THE LAUREL
BITTENHOUSE SQUARE

ZONING CHARTS AND CALCULATIONS AND SKYPLANE DIAGRAMS

Reference: 1911 Walnut Street – Updated Zoning Plan Submission

RE: 1911 Walnut Street – Sky Plane Compliance

Sheet Number: Z1.02

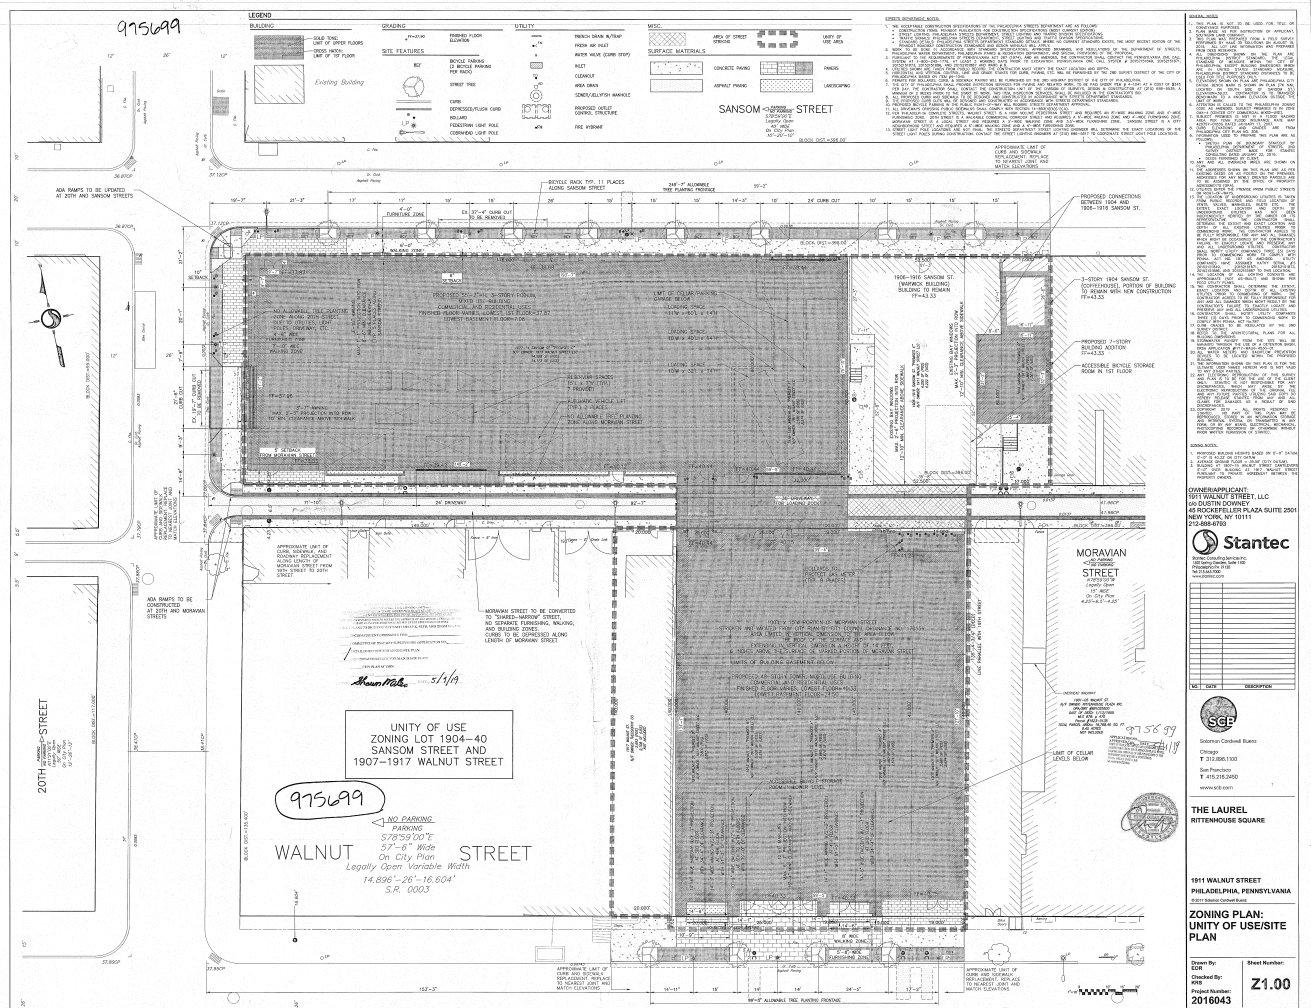
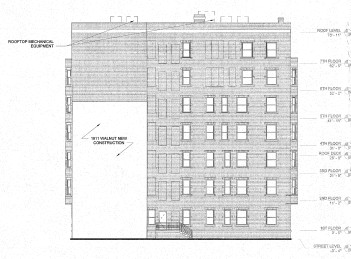
Sheet Z1.02:

- Skyplane diagrams have been updated.
- Total square footage and unit counts have been updated in spreadsheets, including 2 additional residential units in the ground floor of Warwick.
 - Units in the Laurel has changed from (265) to (250).
 - Units in the Warwick has changed from (30) to (32).
 - Total project square footage changed from (530,940 SF) to (516,468 SF).
- Car parking count total has been updated in spreadsheet.
 - Total spaces have changed from (174) to (208).
- Bicycle parking count total has been updated in spreadsheet.
 - Formerly (100) spaces in the Laurel now (84) in Laurel and (10) in Warwick.
- Reservoir space count total has been updated in spreadsheet.
